TF16-002a

ITB17-001a

FLUID LEAK CAUSED BY TRANSFER ASSEMBLY RIGHT SIDE DRIVE SHAFT SEAL

APPLIED VEHICLES: 2014-2020 QX60 (L50)
 2014-2017 QX60 Hybrid (L50)
 2019-2020 QX50 (J55)

Figure 1

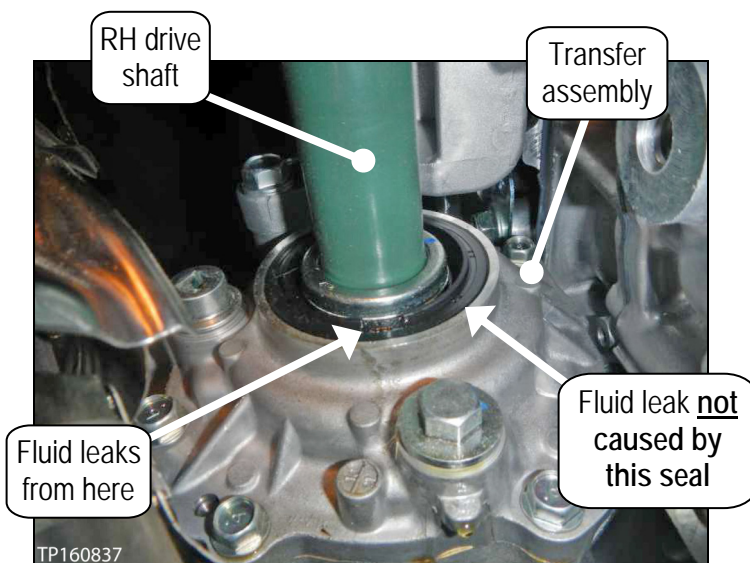
Fluid is leaking from the right side of the transfer assembly (see Figure 1).

NOTE: The fluid leak is not caused by the seal shown in Figure 1.

1. **DO NOT REPLACE** the transfer assembly.
2. Reseal the transfer assembly.
 - Refer to the Electronic Service Manual (ESM), section **DLN – Driveline** or **TRANSMISSION & DRIVELINE > DRIVELINE > TRANSFER: TY21C - UNIT REMOVAL AND INSTALLATION > TRANSFER ASSEMBLY** for transfer assembly removal, reseal, and installation information.
 - Refer to page 2 and 3 for additional information.

CAUTION: Be careful not to damage the transfer assembly right side drive shaft seal when reinstalling the drive shaft.
